LUPIN MINES INCORPORATED

## 2020 Updated Final Closure and Reclamation Plan

### *Technical Comment Responses*

**Nunavut Water Board**

**TITLE**  
UNDERGROUND MINE WORKING PLAN

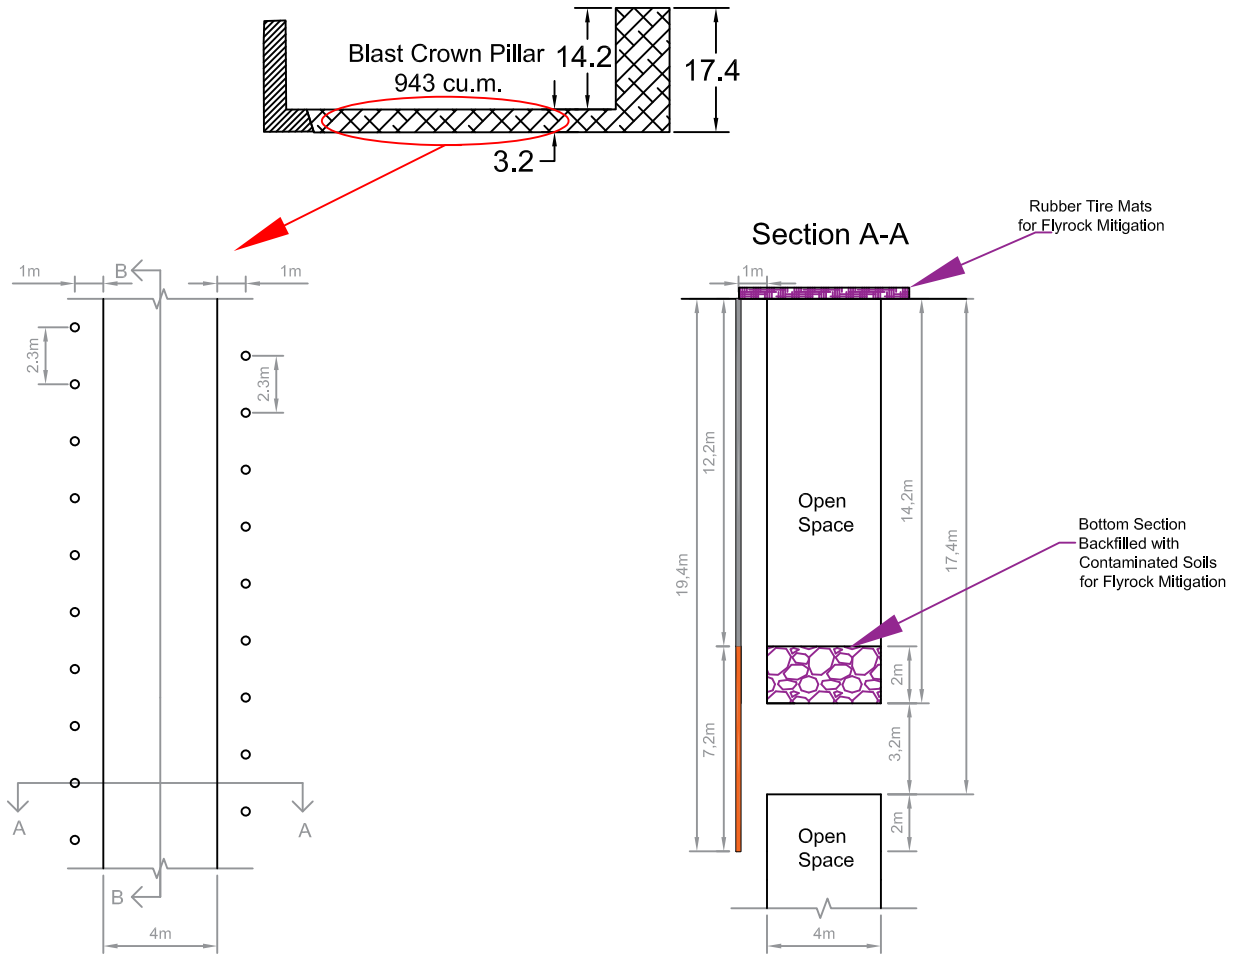
Discussion of closure of the underground and placement of material into the underground is found in the Executive Summary 5a) and Section 4.3.2.4 Underground Workings, and in Figures 6, 13, and 14. Review of these sections notes that on page 4- 14 LMI states the Preferred Reclamation activities will; *"modify the previous plan for the West Zone disposal as shown on Figure 14. The modified plan would address the void areas and increase the storage capacity. Instead of developing additional drop raises in the remaining crown pillar for disposal, the new plan would be to blast down the remaining crown pillar, creating an open slope trench approximately 260 m in length and approximately 72 m deep"*.

- Figure 6 notes that it provides a Site Plan showing the West Zone and provides some notes on open depths and a "ramp" in the areas referred to as WZ Crown Pillar Pit and WZ Underground Disposal Key Cross Section Locations (5).

- Figure 6 notes that it provides a Site Plan showing the West Zone and provides some notes on open depths and a "ramp" in the areas referred to as WZ Crown Pillar Pit and WZ Underground Disposal Key Cross Section Locations (5).

- ii) As shown on Figure 10, the entire west zone crown pillar area will fall within the footprint of the waste rock "dome". As shown on Figure 6, the ground surface elevation along the open crown pillar generally varies between Elev. 502 and 501 m, with lower elevations on the north end. Comparing this to the dome grading plan (TM of June 8, 2020 in response to condition E-25) shows that the total cover over the crown pillar (including the 1 m esker cover) will generally be about 4 m. It is expected that most of the fill subsidence will occur while the dome is being constructed and so it will be accommodated in the final grading. Any long-term subsidence can be corrected by placing additional esker material in the subsidence area to bring it back up to grade. A small volume of esker material will be stockpiled on the dome for this purpose.
